SUBJECT: ADDENDUM No. 1
BID Solicitation Number: 7205855-8910

Addendum Number One (1): Electrical Installation Work – Standby Generator
Pre-Bid Meeting – Electrical Installation Work – Generator Meeting Notes for January 5, 2011
Pre-Bid Meeting for Standby Generator Electrical Installation Work – Guest Sign-In Sheet
Digital photos of main breaker bus bar connections
Sheet E-03: Main Switchboard MSDB
Automatic Transfer Switch Drawings – 8 Pages

Addendum Number One (1)
Electrical Installation Work – Standby Generator

PROJECT DESCRIPTION: CITY OF PRESCOTT, AZ
SUNDOG WWTP
STANDBY GENERATOR

Top
Back
Low Middle
Back

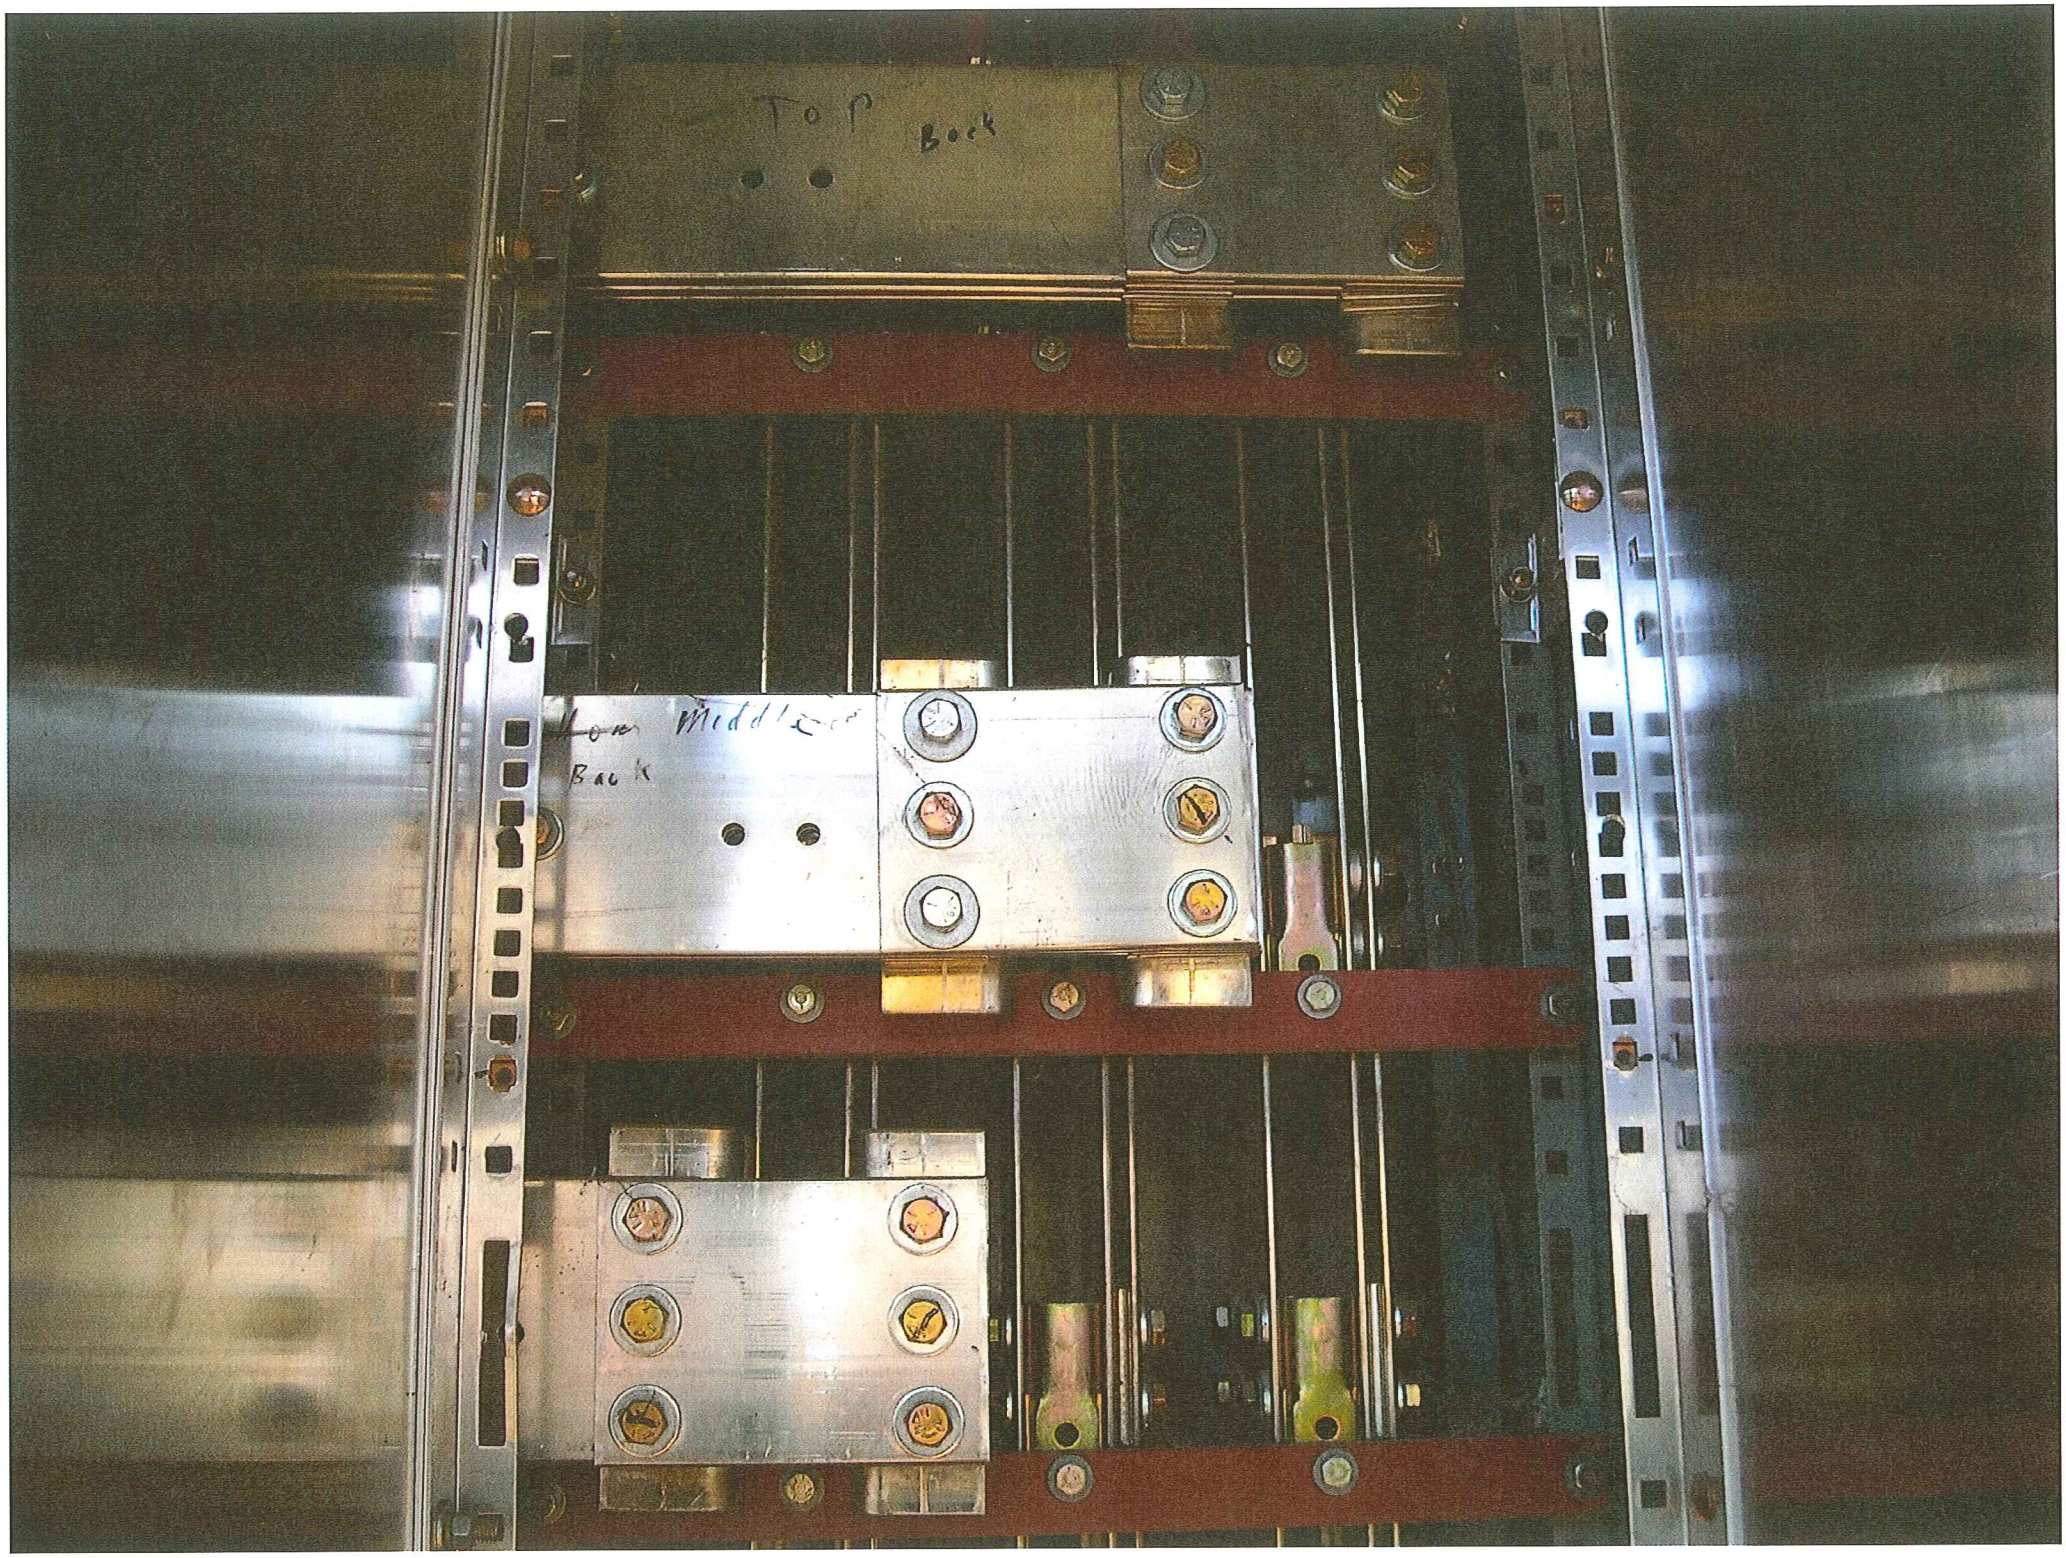
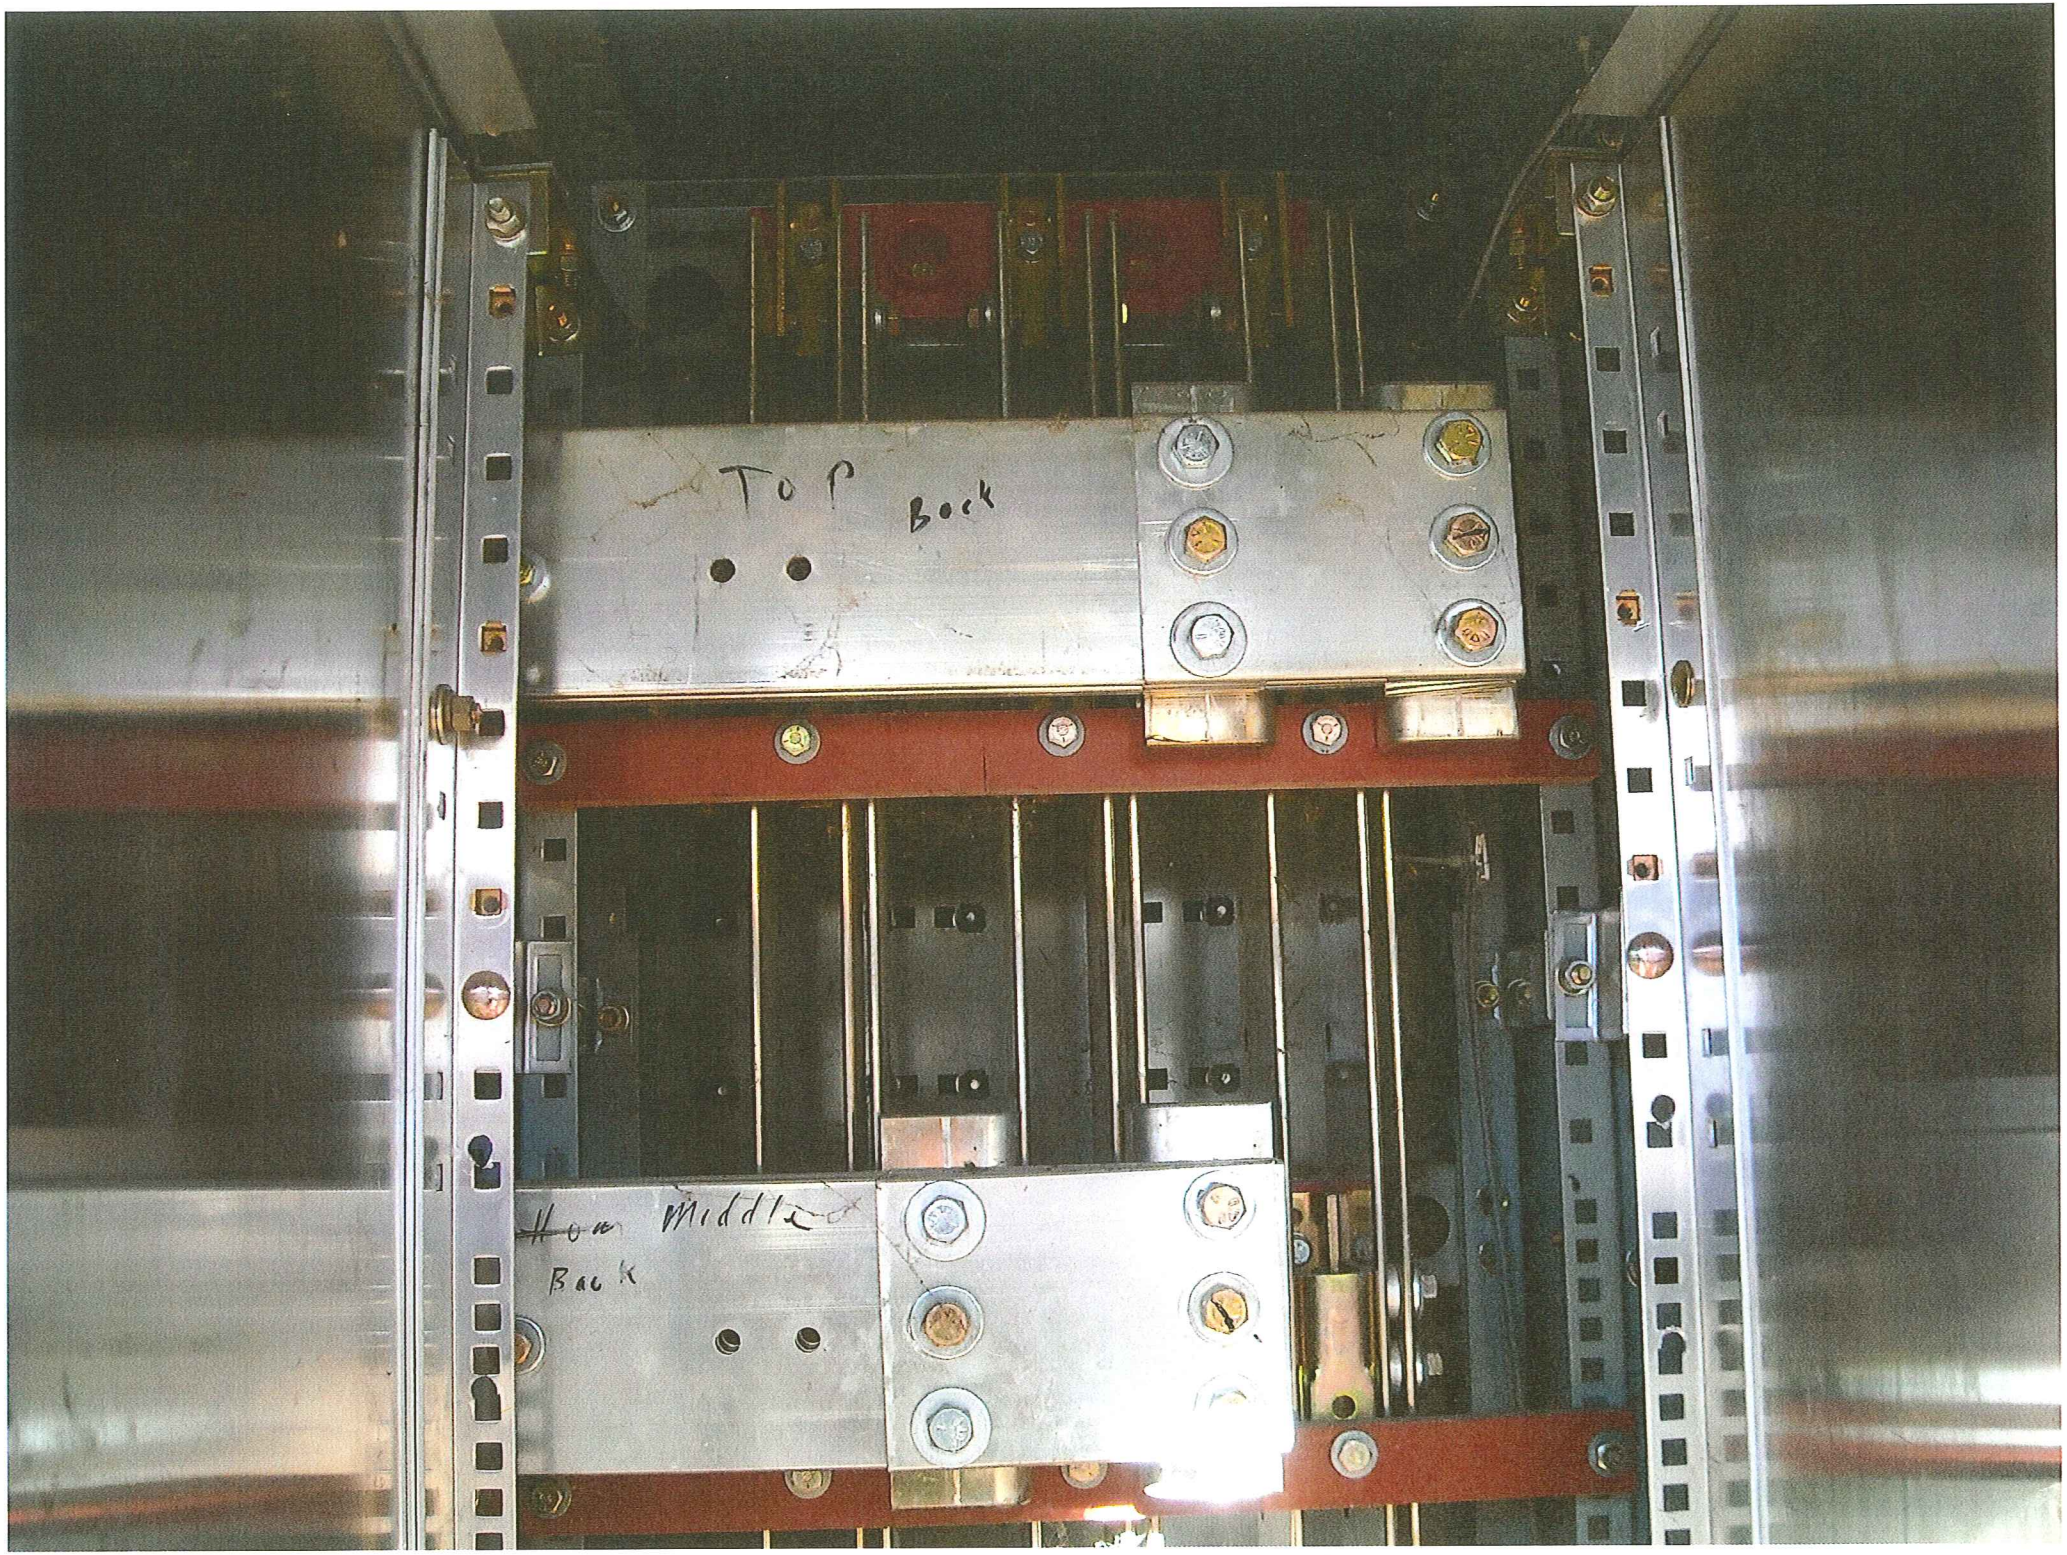
As notified previously by e-mail, an APS shutdown was done on Wednesday, January 12, 2011 at 9:30 am to access the inner switchboard panels and to allow for a physical inspection and pictures to be taken. Pictures are included in this addendum and will be e-mailed to each prospective bidder by COB Wednesday, January 12, 2011.

A MAIN SWITCHBOARD MSDB
SCALE: N.T.S
FILE: 8214A.10-E-03

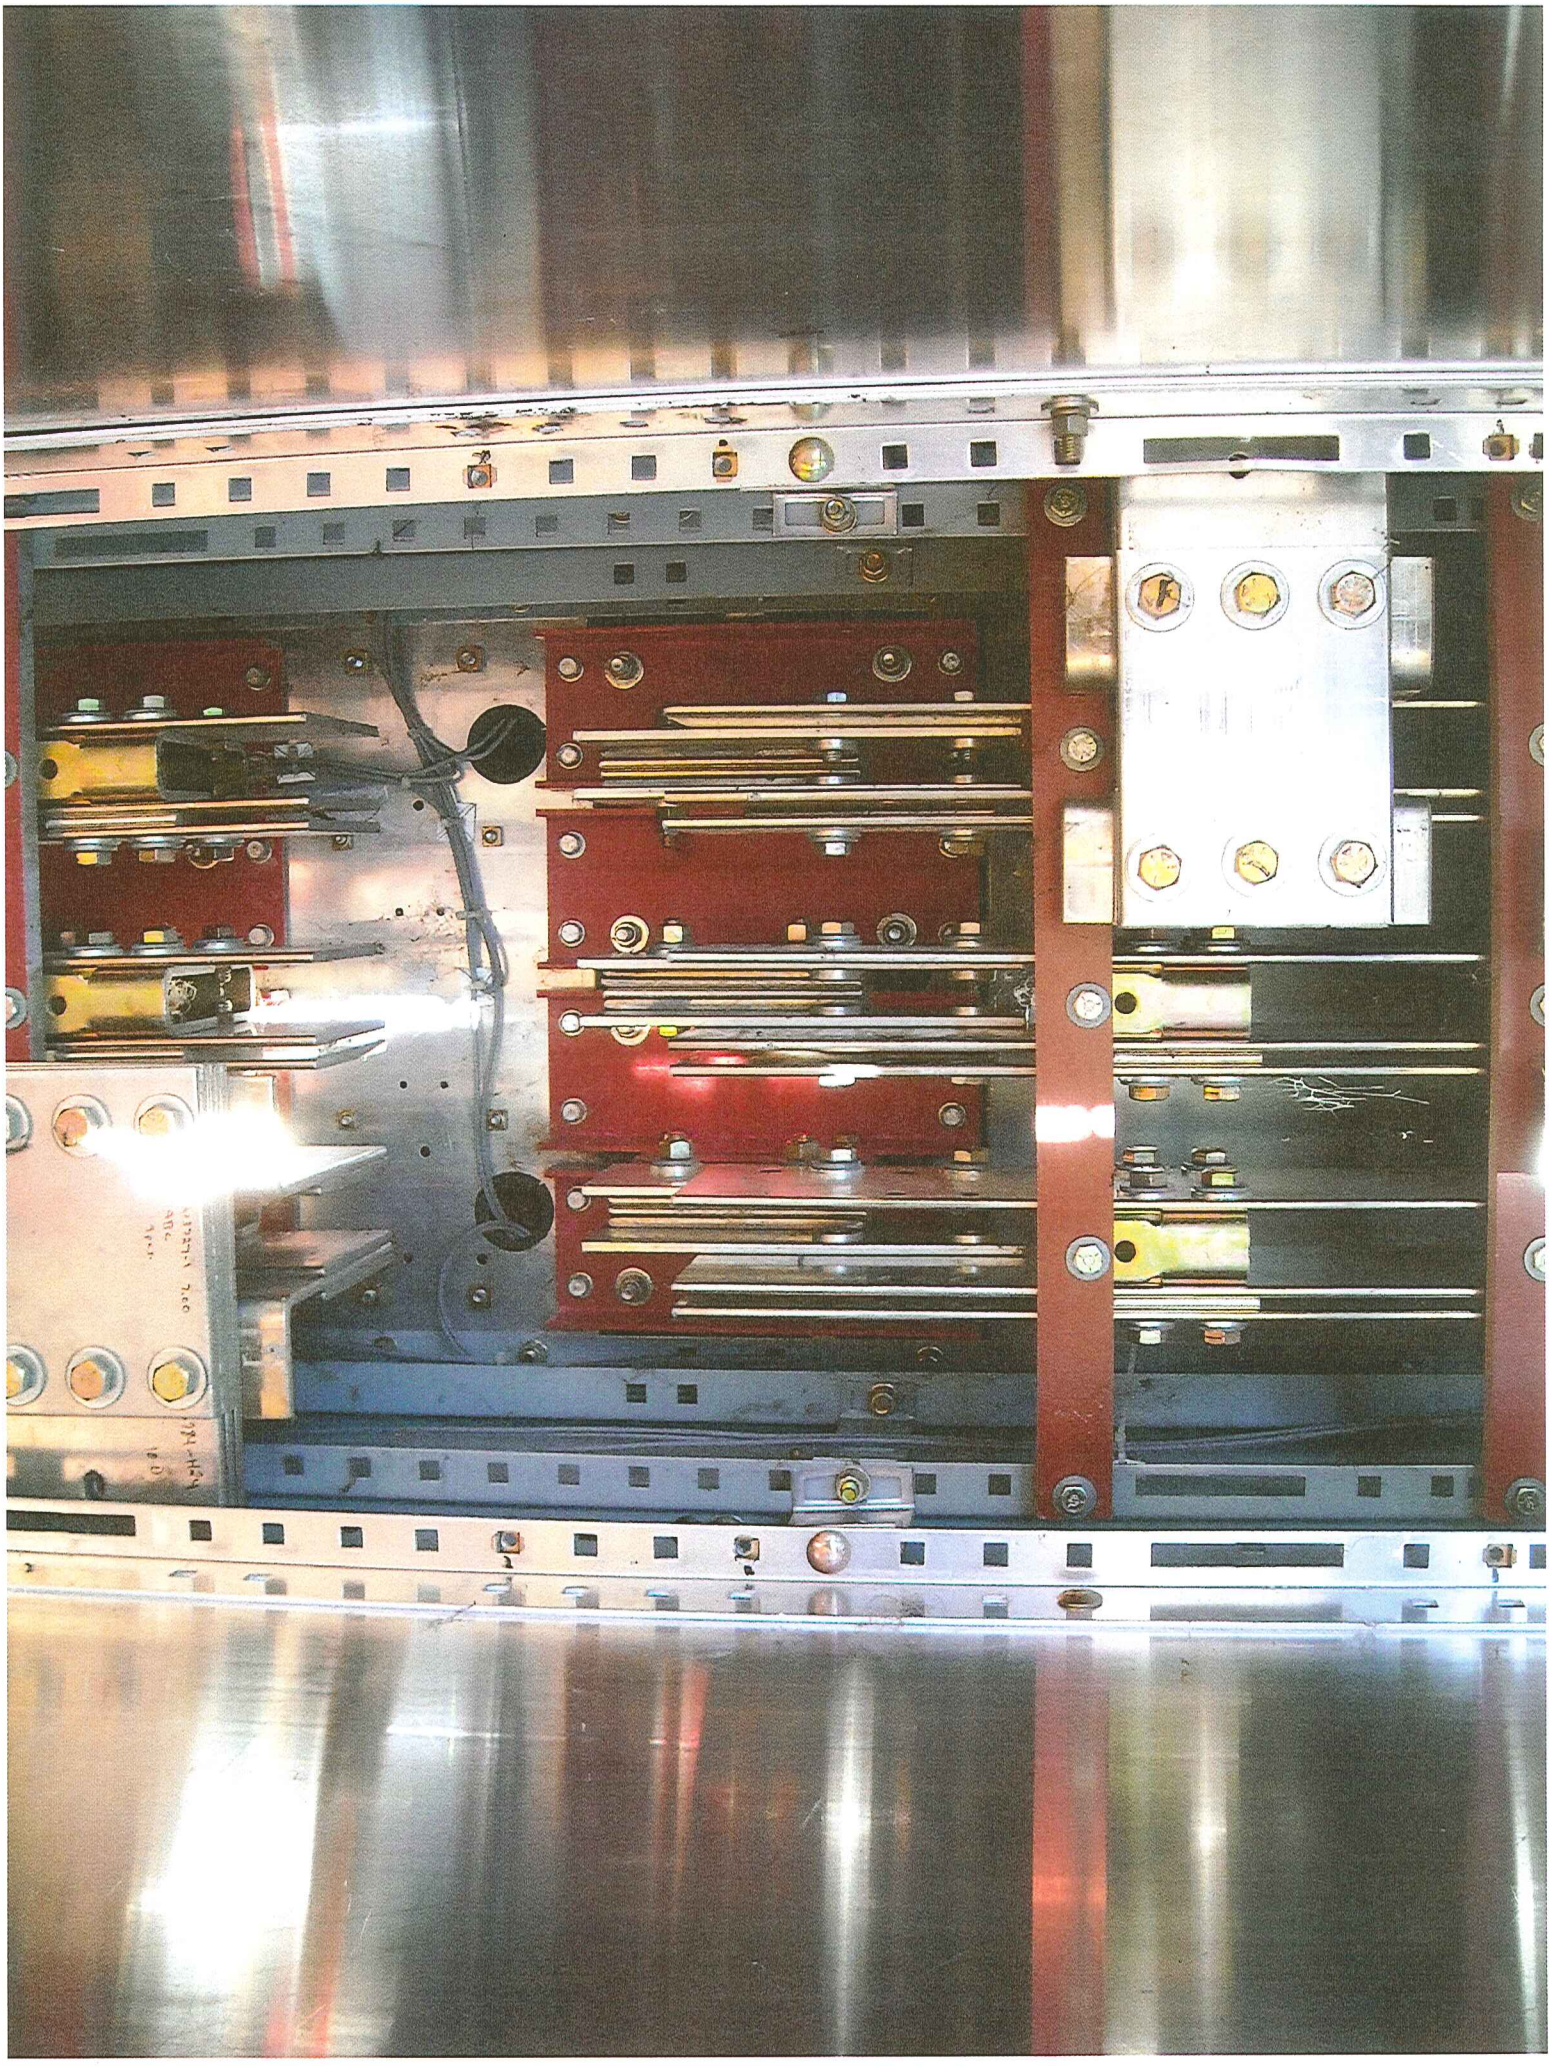
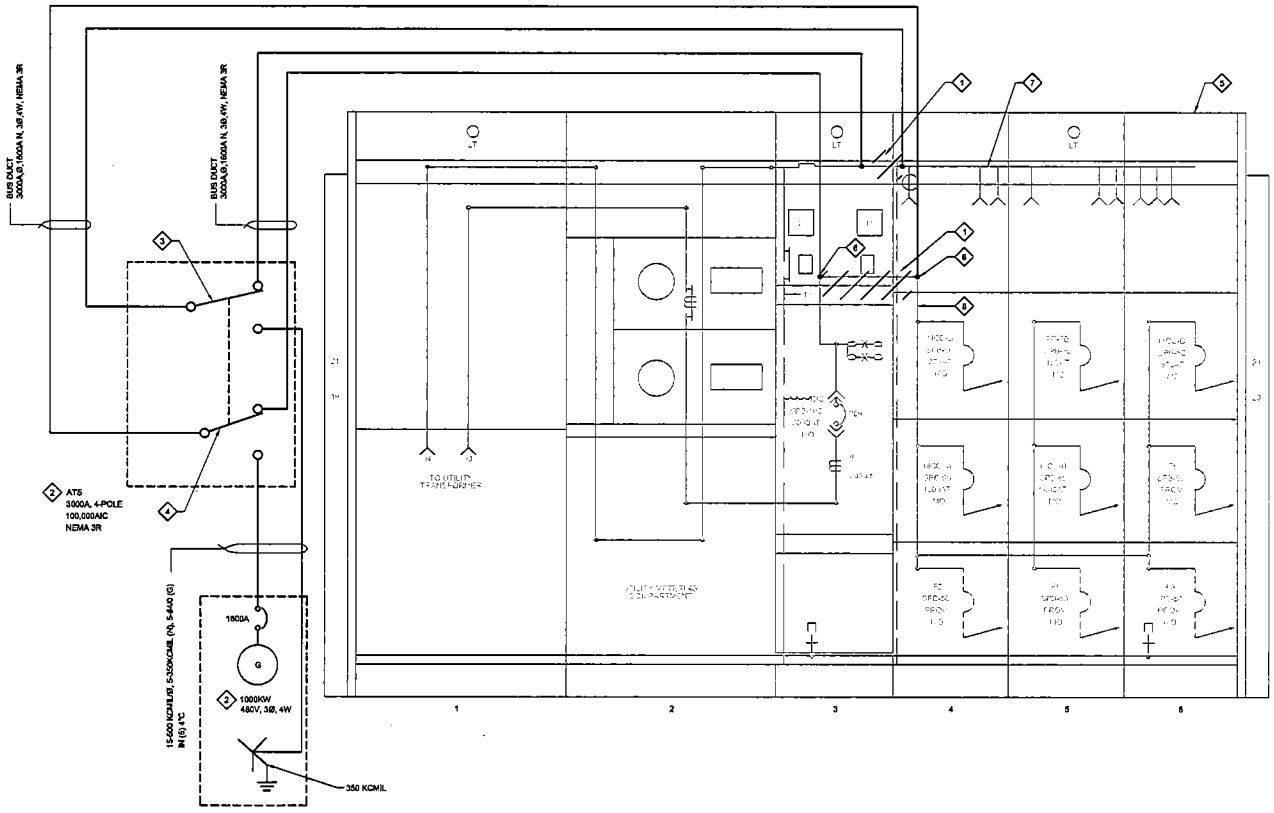
Drawing Number E-03 Main Switchboard MSDB has been revised to correct the wire routing error from the Automatic Transfer Switch to the Main Switchboard. Note One (1) and Note Six (6) on drawing E-03 were inapplicable for the project and were deleted from the sheet.
